# HERITAGE PRESERVATION COMMISSION REPORT

Certificate of Appropriateness for Major Work- 10<sup>th</sup> & Cass Historic District.

**MEETING DATE:** January 26, 2023

**PROPOSAL:** The applicant is proposing to make exterior renovations and alterations to the exterior facades of the property located at 928 King Street.

## Existing Garage Elevations

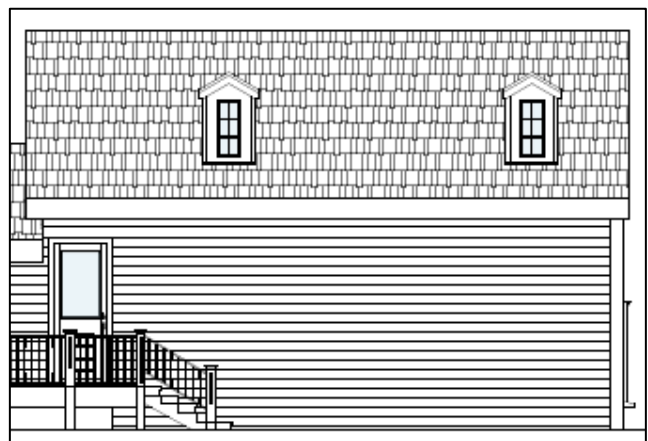
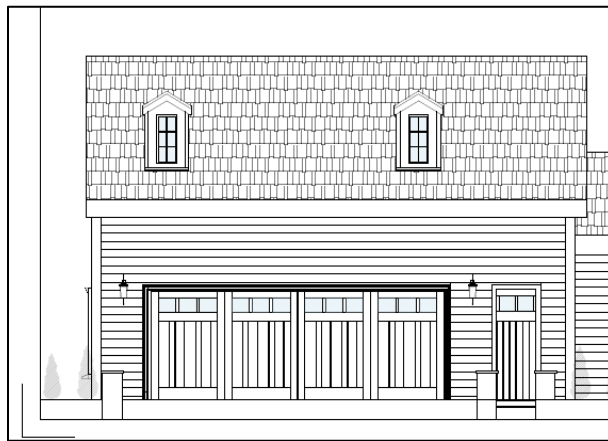
The applicant is proposing to add four dormers to the pitched roof. Two will be facing to east and two will be facing to the west. The applicant is also proposing to remove the existing west façade wall and install a new overhead garage door. A new door will also be installed in the same location as the existing one. The applicant will then remove the overhead garage door on the south façade and install a new wall with three windows. The applicant wants to also relocate the curb cut, remove the large driveway, install a new sidewalk around the garage, and replace it all with grass and greenspace.
